MANDATORY SERVICE BULLETIN MSB 40NG-015/1

I.5 Subject

Installation of a rudder cable guard.

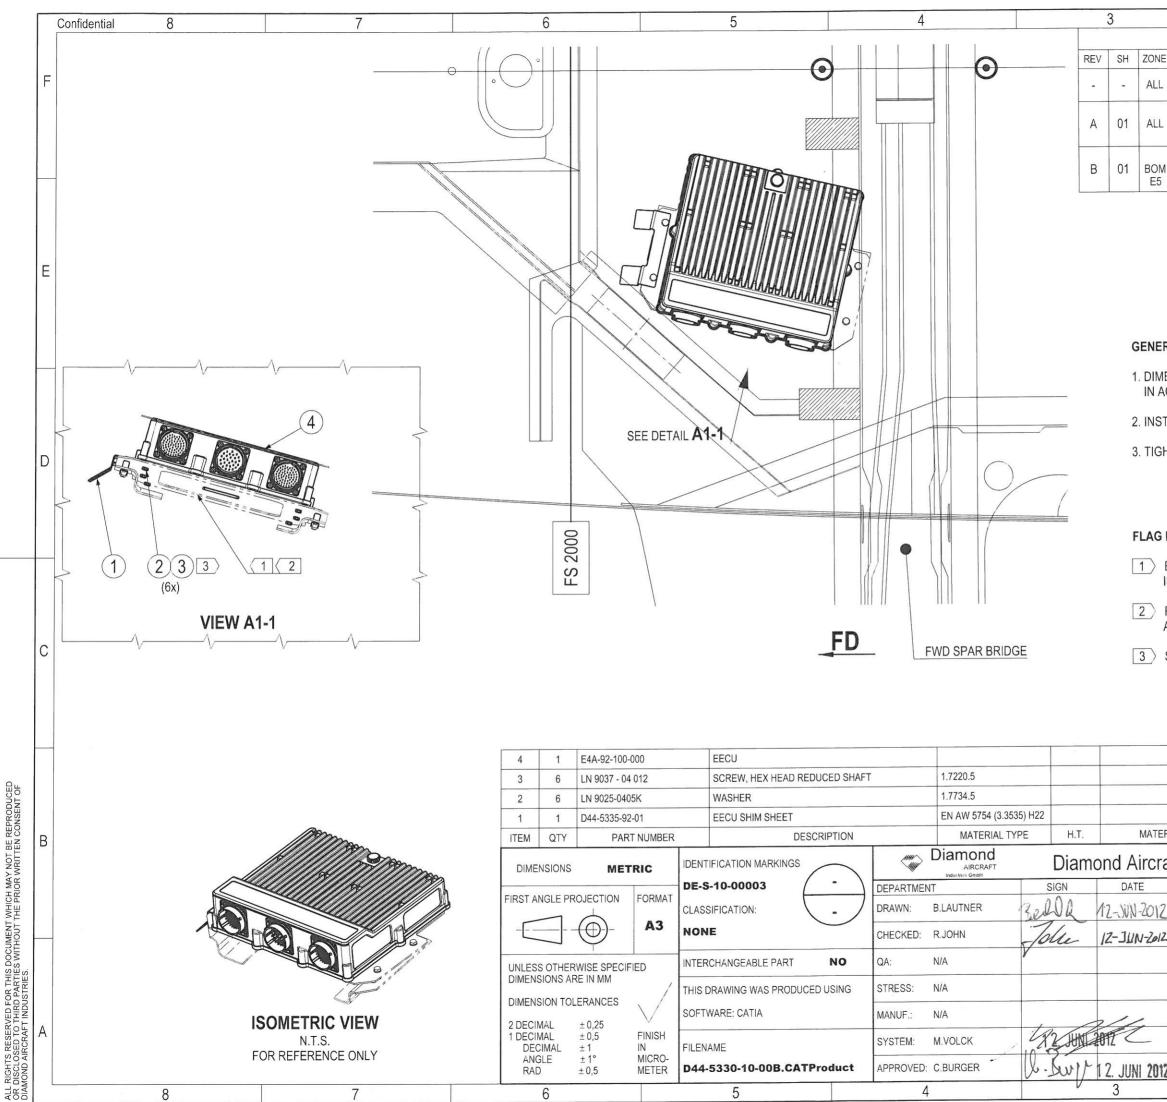
During Maintenance it was discovered that the EECU attachment screws can possible catch the rudder cable, if the pilot's left rudder pedal is pulled back by hand completely and released. If not discovered and corrected this could lead to limited rudder authority and increased pilot work load.

1	Remove Pilot Seat i.a.w. AMM Section 25-10.				
2	Examine rudder cable for damage and chafing marks. Replace, if necessary.				
3	Install EECU Shim sheet D44-5335-92-01 i.a.w. drawing D44-5330-10-00.				
	Make sure the gap between the EECU Shim Sheet and the floor structure is less than 1 mm.				
4	Install Pilot Seat i.a.w. AMM Section 25-10.				
5	Clean working areas, check for foreign objects.				
6	Check all altered, replaced, repaired parts for proper function.				
7	Test all systems in working area for function.				
8	Make all necessary entries in the airplane logs.
